SB Number:	SB 2C9-011	Creation Date: 01/10/2004
Subject:	Improvement of 'STRAP LEFT COVER A/B'	
Model:	KM-1620 / 2020

CONTENTS OF CHANGES

NEW shape of 'STRAP LEFT COVER A/B'

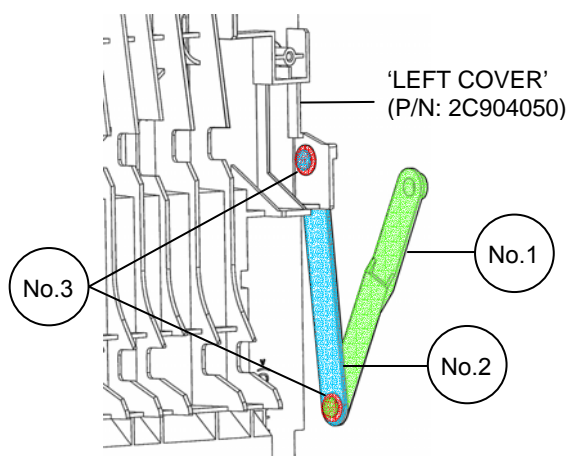
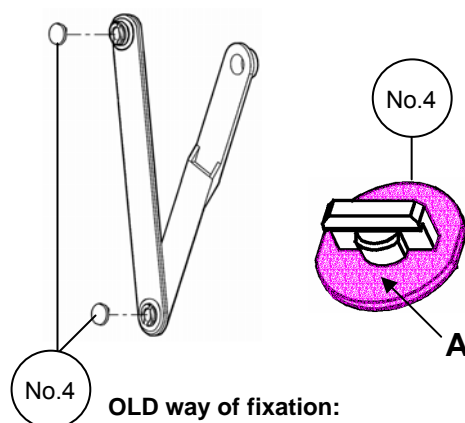
The way of fixing the '**STRAP LEFT COVER A/B**' (No.1, No.2) has been changed so that the strap attached to the back side of '**LEFT COVER**' (P/N: 2C904050) does not come off easily.

- 1) The fixation of '**STRAP LEFT COVER A/B**' has been changed from '**PIN STRAP**' (No.4) to '**CUT WASHER 5**' (No.3).
- 2) In compliance with change 1, the shape of the '**STRAP LEFT COVER A/B**' has been changed as well.

Fit the 'CUT WASHER 5' into the groove at the end of 'STRAP LEFT COVER A/B' and fix.

Insert 'PIN STRAP' into the hole in 'STRAP LEFT COVER A/B' and press down the strap with plastic holder ('A' part) and fix.

When replacing old with new parts, please replace no 1 through 3 at the same time.
